STAFF REPORT COMMUNITY DEVELOPMENT DEPARTMENT

SUBJECT: FP-2021-0001
Delano No. 1

Final plat consisting of 60 buildable lots and 9 common lots on 10.45 acres of land in the R-8, R-15 and R-40 zoning districts for the first phase of Delano Subdivision.

B. Final Plat (dated: 1/5/21)

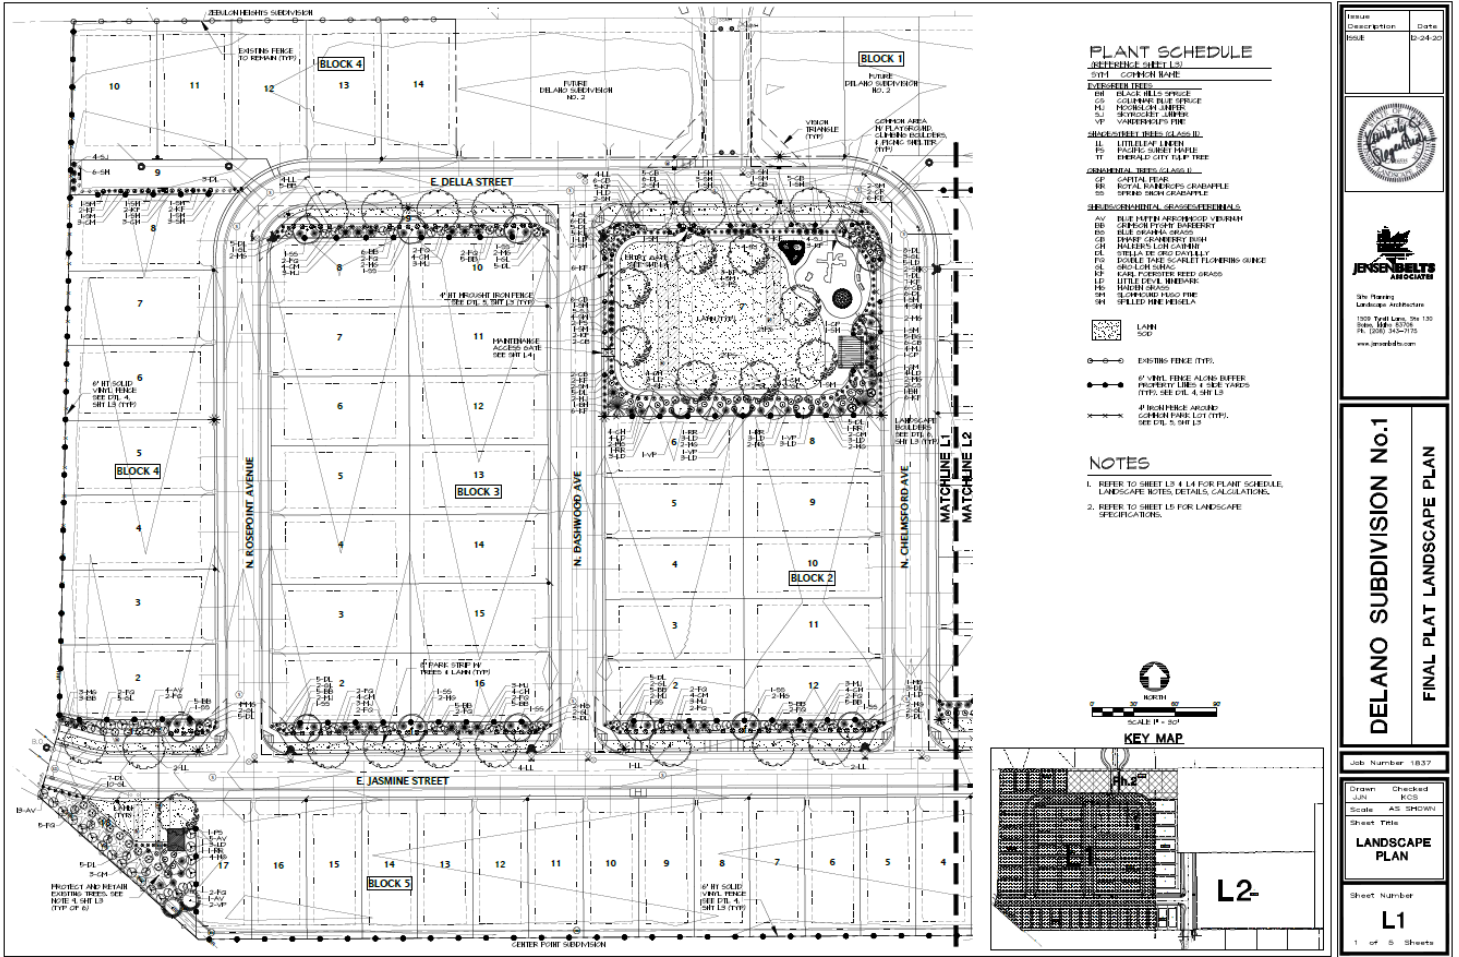
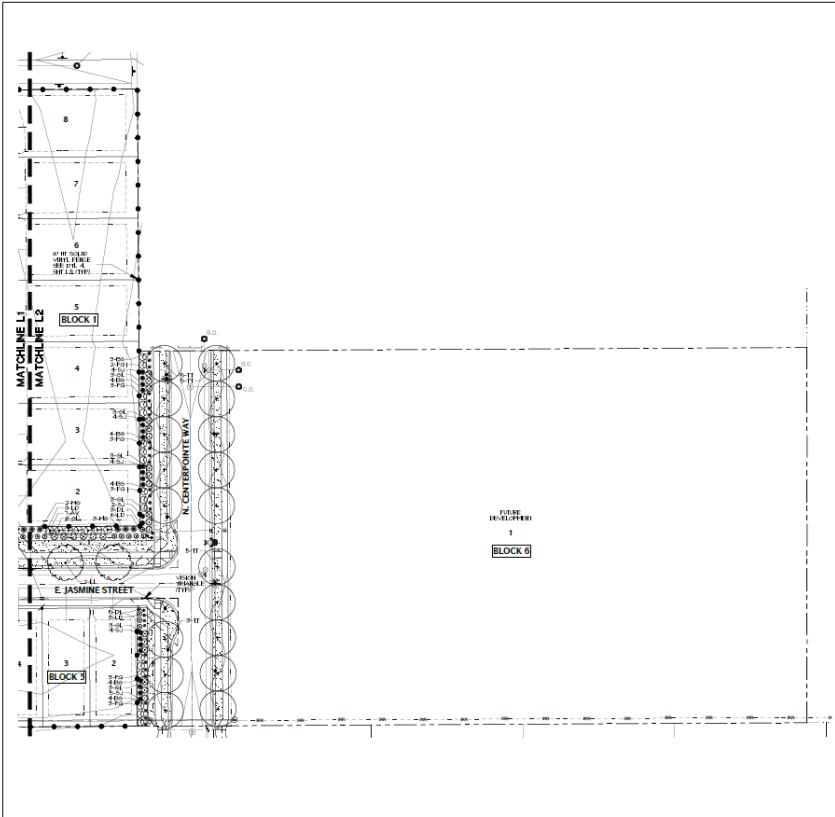
1. Applicant shall comply with all previous conditions of approval associated with this development (H-2019-0027; Development Agreement Instrument Number 2020-131190).
2. The applicant shall obtain the City Engineer's signature on the subject final plat within two years of the City Council's approval of the preliminary plat (on or before August 11, 2022); *or* apply for a time extension, in accord with UDC 11-6B-7.
3. Prior to submittal for the City Engineer's signature, have the Certificate of Owners and the accompanying acknowledgement signed and notarized.
4. The final plat prepared by Sawtooth Land Surveying, LLC stamped by Jeff Beagley, dated: 1/5/2021, included in Section V.B shall be revised as follows:

- a. Plat Note #4: “. . . Meridian City Code ~~unless otherwise modified by conditional use permit.~~”
- b. Plat Note #7: Include the ACHD License Agreement recorded instrument number.
- c. Plat Note #11: Include ACHD sidewalk easement recorded instrument number.
- d. Plat Note #12: Remove note as it's not applicable.

- e. Include the recorded instrument number of the 30' water/sewer easement.

- f. Depict the common lot lot line for Lots 1 and 7, Block 2.
- g. Depict the street buffer on Lot 1, Block 6 in a minimum 20-foot wide common lot as set forth in UDC 11-3B-7C.2a; and include lot and block number in Note #6.
- h. Depict the Block number (i.e. Block 1) on Sheet 1.
- i. Include the Phase # (i.e. 1) in the subdivision name.
- j. Depict the location of the cross-access/ingress-egress easement on Lot 1, Block 6 to the east to Parcel #R4582530202 required in condition #12 below.

A copy of the revised plat shall be submitted with the final plat for City Engineer signature.

C. Landscape Plan (dated: 12/24/2020) & Amenity Details

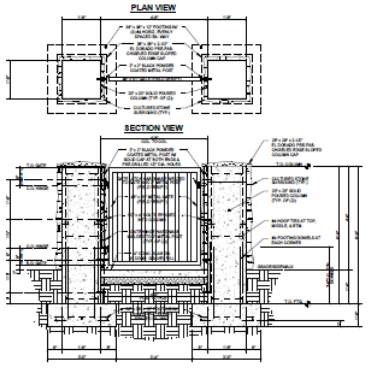
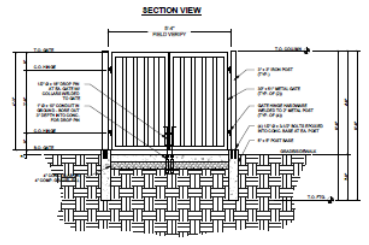
5. The landscape plan prepared by Jensen Belts Associates, dated 12/24/2020, included in Section V.C, shall be revised as follows:
 - a. Depict the location of the proposed swing set on Lot 7, Block 2 and public art on Lot 18, Block 5 on the plan.
 - b. Widen the street buffer along the east side of N. Centrepoint Way to a minimum of 20-feet and depict landscaping in the entire street buffer in accord with the standards listed in UDC 11-3B-7C.3. Depict trees *and* shrubs in the street buffer along the east side of N. Centrepoint Way. Depict the street buffer in a common lot as required in condition #4.g above.
 - c. Correct the street names consistent with that shown on the plat (i.e. E. Della St. should be W. Eagle View St.; N. Rosepoint Ave. should be N. Amberwood Ave.; and N. Centerpoint Way should be N. Centrepoint Way).

- d. Include the linear feet of parkways and the required vs. proposed number of trees in the Landscape Calculations table demonstrating compliance with the standards in UDC 11-3A-17 and 11-3B-7C.

D. Common Driveway Exhibit

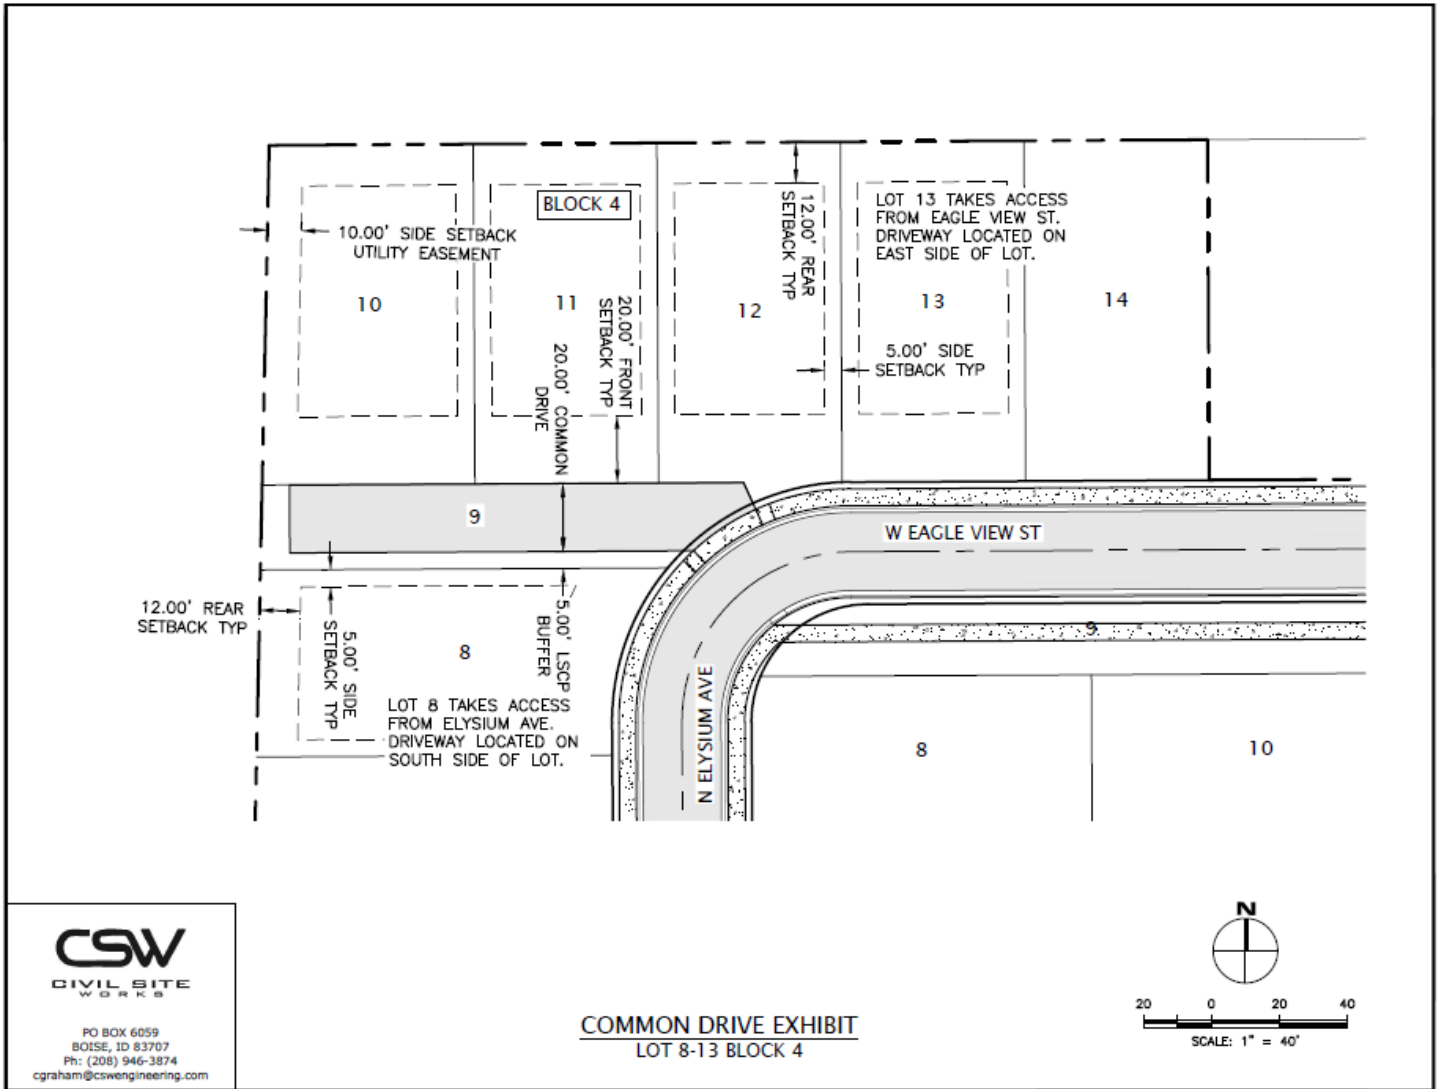
15. Provide address signage for homes accessed by the common driveway on Lot 9, Block 4 at the entrance of the common driveway from the public street for emergency wayfinding purposes.

16. A perpetual ingress/egress easement is required to be filed with the Ada County Recorder for all common driveways, which shall include a requirement for maintenance of a paved surface capable of supporting fire vehicles and equipment. A copy of the recorded easement shall be submitted to the Planning Division prior to signature on the final plat by the City Engineer.

E. Emergency Access Exhibit

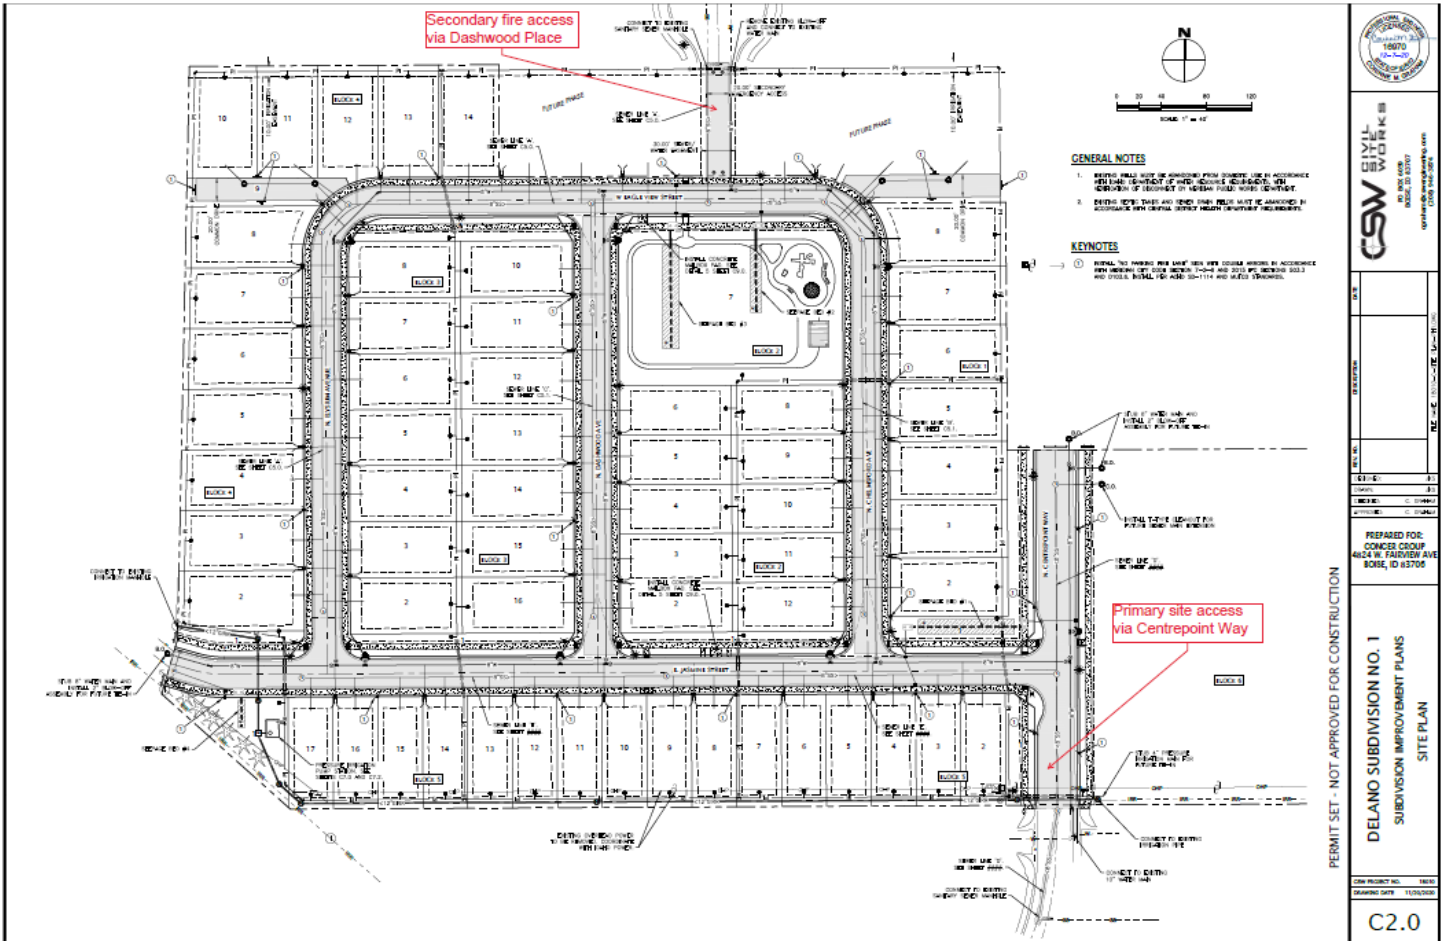
11. The emergency access driveway from N. Dashwood Pl. to E. Eagle View St. at the northern boundary of the site shall be constructed with the first phase of development as shown in Section V.E; this access shall serve as emergency and pedestrian access *only* and shall not be extended (now or in the future) as a public street. Bollards shall be installed at each end of the access driveway as depicted on the landscape plan that comply with Fire Dept. requirements.
